P-11794 13527

(JINDAL)	DL OF QUALITY  BANGALORE-560073 (INDIA)		NAME	DATE
		DRAWN	PARVESH	20-08-2013
CYALDOL OF OHALITY		CHECKED		
AN ISO 9001 COMPANY		APPROVED	S.S.GARG	21-08-2013
ALL DIMENSIONS ARE IN mm.     ROUND OFF ALL SHARP CORNERS WITH 0.40 mm.     TOLERANCES WILL BE AS PER IS:2673-2002, UNLESS OTHERWISE SPECIFIED		SCALE		1:1
		AREA mm <sup>2</sup>		491.345
		PERIMETER mm.		251.956
PARTY'S NAME	OWN USE	WEIGHT kg	/m	1.327
		DRAWING	No. SE	CTION No.
PARTY'S DRAWING No.	AS PER SPECIFICATION	P-11794	_	-
	LIFO, WD	13527 1352		27 (ISSUE-4)
ALLOY & TEMPER	HE9 WP			
DESCRIPTION	ROUND TUBE

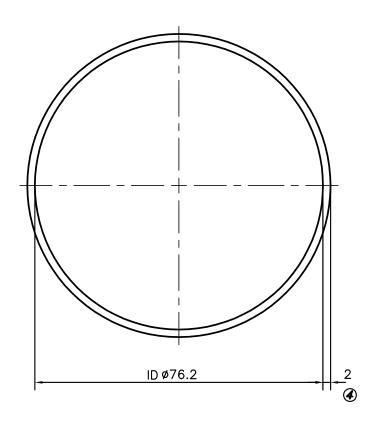
- ISSUE :- 2 (DATED-5/9/2012)
  THICKNESS REDUCED FROM 2 mm. TO 1.5 mm. & WEIGHT ALSO CHANGED FROM 1.327 Kg/m TO 0.989 Kg/m.
- ISSUE :- 3 (DATED-29/01/2013)
  THICKNESS INCREASED FROM 1.5 mm. TO 3 mm. & WEIGHT ALSO CHANGED FROM 0.989 Kg/m TO 2.015 Kg/m.
- ISSUE :- 4 (DATED-20/8/2013)
  THICKNESS REDUCED FROM 3 mm. TO 2 mm. & WEIGHT ALSO CHANGED FROM 2.015 Kg/m TO 1.327 Kg/m.
